**CITY OF GRANT  
PLANNING COMMISSION MEETING**

## STAFF REPORT

**RE:** Application for an Amended  
Conditional Use Permit for Woodbury  
Lutheran Church at 9050 60<sup>th</sup> Street N

Attachment B: Construction Plan – Sheet C1 (Site Plan)

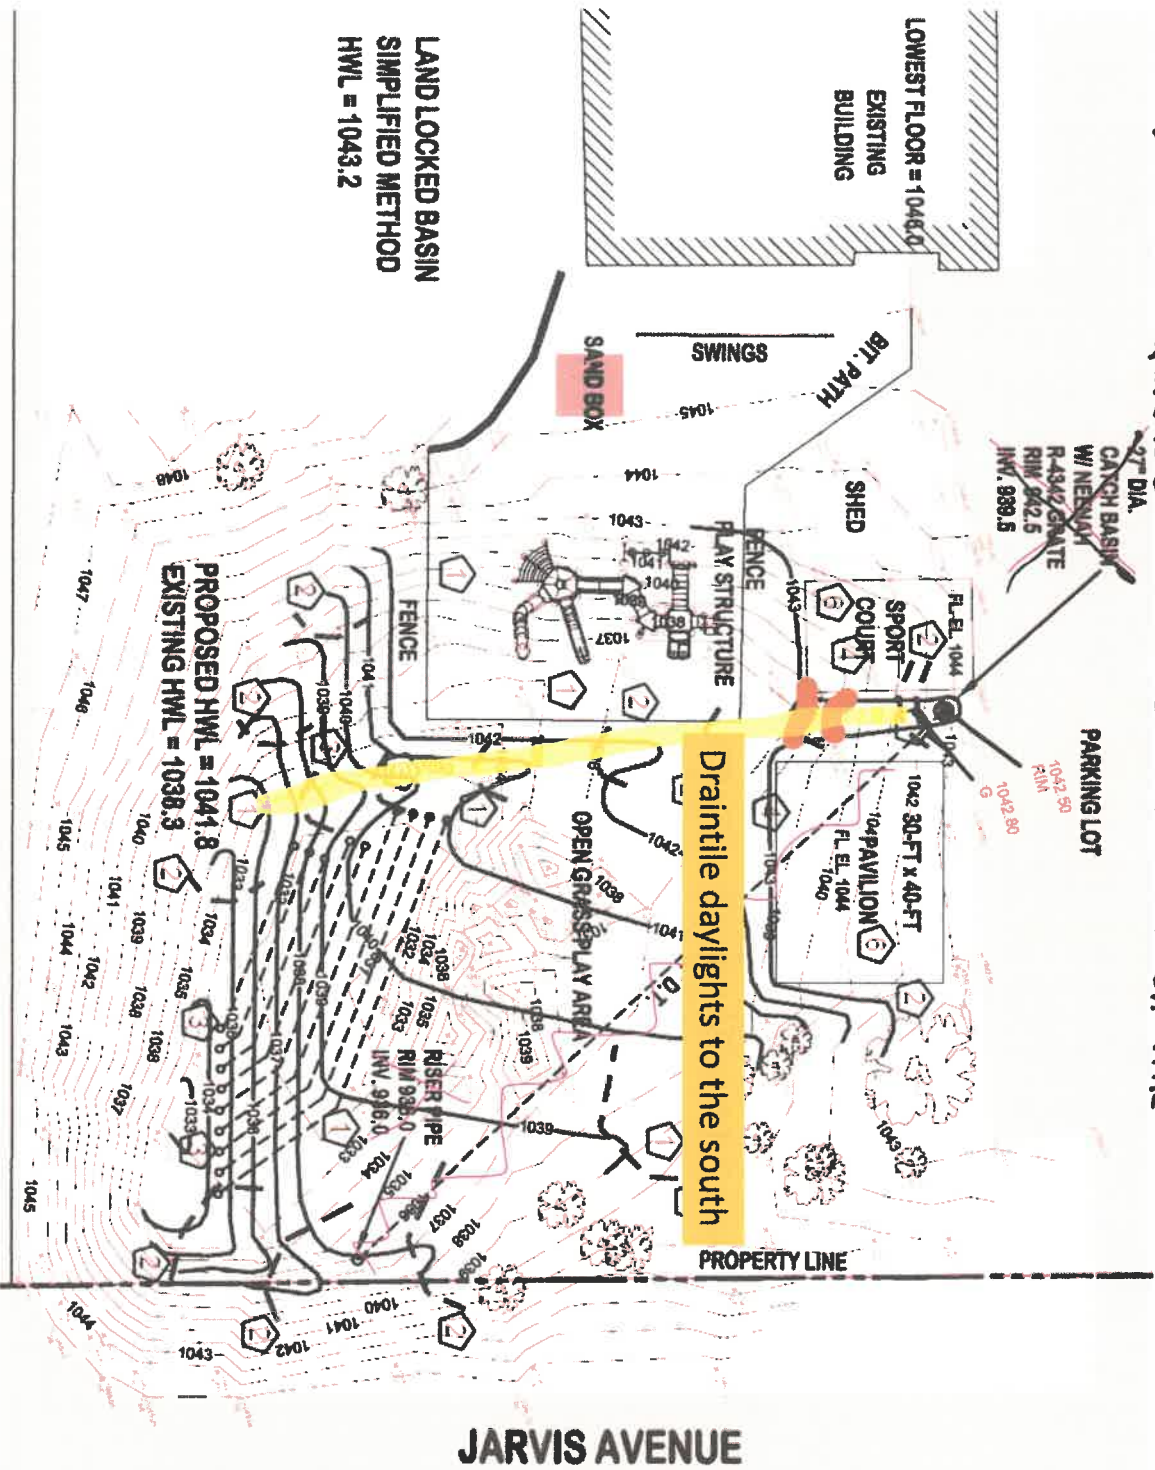
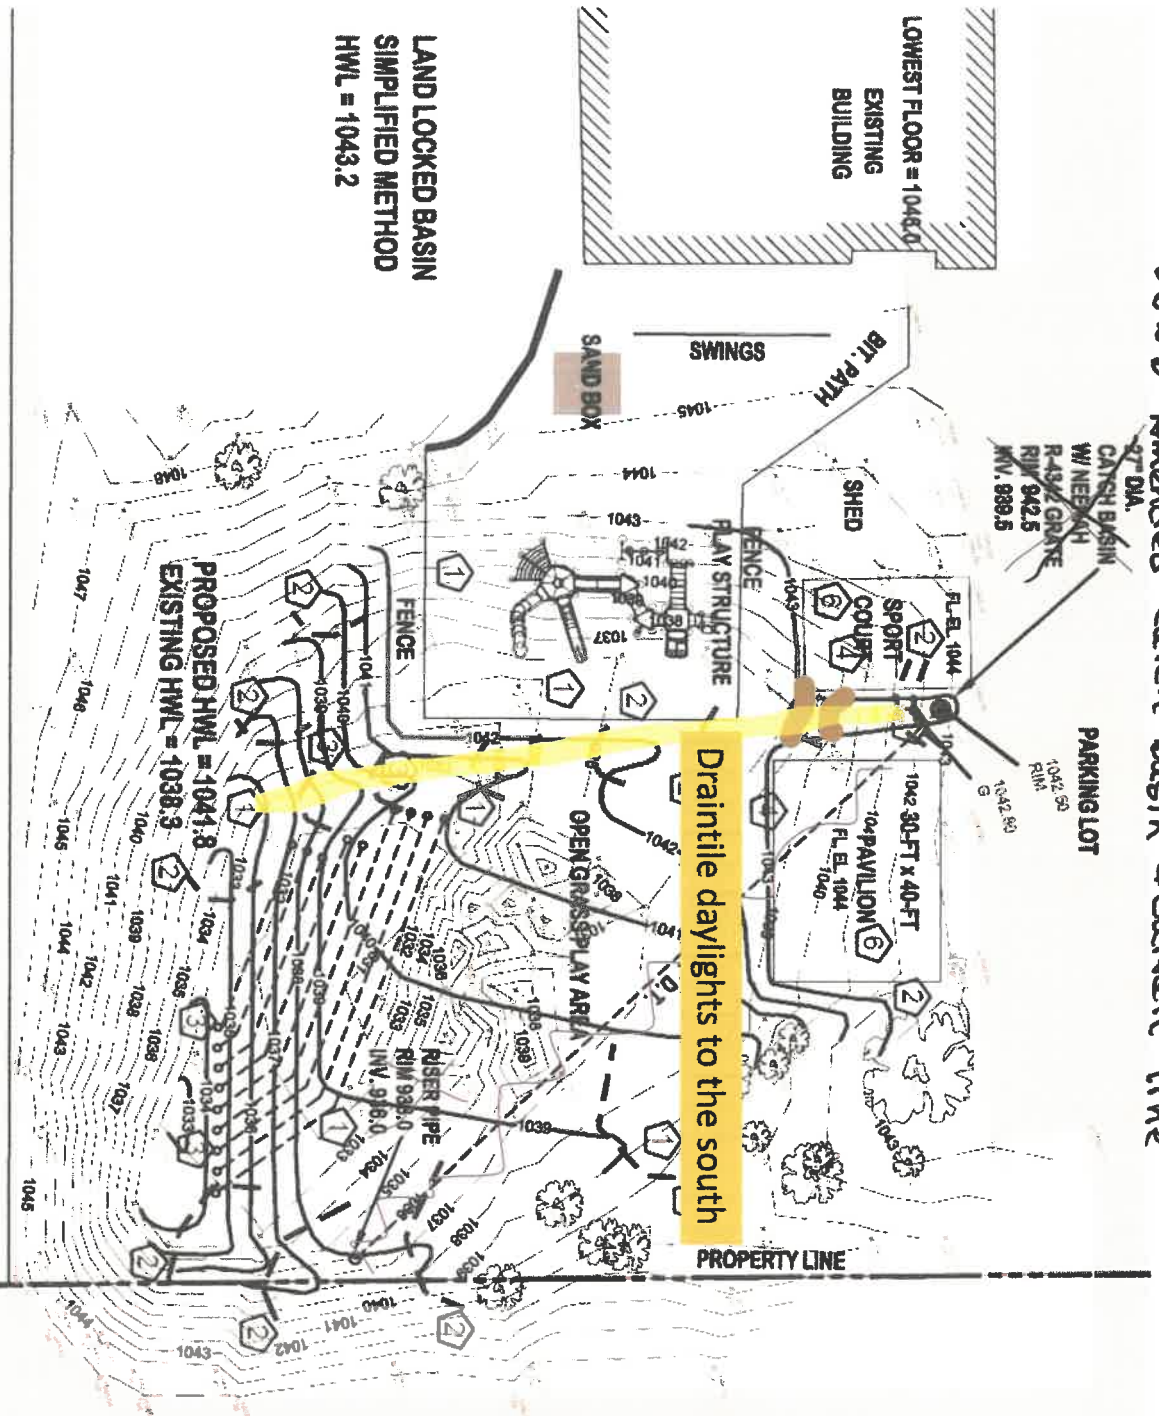
As shown on the Construction Plan, the proposed pavilion and play structure are located southeast of the existing building. The proposed pavilion is setback approximately 55-feet from the easterly property line (75-feet from the traveled surface of Jarvis Avenue), 5-feet from the existing parking lot on-site, and 130-feet from 60<sup>th</sup> Street N. The play structure area is setback approximately 100-feet from the easterly property line, and 70-feet from the paved road surface of 60<sup>th</sup> Street North. As proposed, the Pavilion does not comply with the side-yard setback for structures on a corner lot. *Staff recommends that the pavilion be shifted or adjusted to meet the required 65-foot setback from Jarvis Avenue N., and that the Site Plan be updated to show the structure meeting the required setback.*

As noted in the submitted application materials, excavation and site work is necessary to construct the sport court, pavilion and play structure. As noted on the Construction Plan, a catch basin will be constructed between the Sport Court and Pavilion near the southern edge of the parking lot and a large swale will be graded into the site to allow for water and drainage to flow to the stormwater area on the southeast corner of the site. The open grass and play area will be reseeded as part of the project. As noted in the narrative, a rain garden and pollinator garden are proposed but are not identified on the plan. *Staff recommends including a condition that the site plan be updated to include the location of the rain garden and pollinator garden prior to the issuance of the grading permit.*

The Construction Plan (Sheet C1) also notes that a Fence will be constructed to surround the Play Structure area. A detail of the fence was not provided as part of the submission. *Staff recommends including a condition that the fence detail, including height and material, must be submitted for review and approval by City Staff prior to issuance of the grading permit.*

Since a part of this project includes the relocation/excavation of stormwater features the City Engineer must review and approve the grading plan, and stormwater plan if necessary. As noted on the Construction Plan, the Existing Drainage Area and Proposed Drainage Area are the same, but there is a slight increase in the amount of impervious surface due to the improvements (increase of approximately 1,800 SF). *Given the improvements contemplated with the proposed development, staff recommends including a condition that the City Engineer must review and approve the Construction Plan, as revised, and that the Applicant must obtain a grading plan prior to the commencement of any work on site.*

- No more than two (2) accessory buildings are permitted on site, and the square footage may not exceed 2,000 square feet.
- The Site Plan must be revised to show the Pavilion meeting all required setbacks, including 65-feet from the easterly property line.

- The Site Plan must be updated to show the location of the rain garden and pollinator garden described in the narrative.
- If applicable, the lighting plan for the area must be submitted for review and approval.

- A detail of the fence, showing the height and material must be submitted for review and approval. The fence location should be clearly identified on the updated Site Plan.
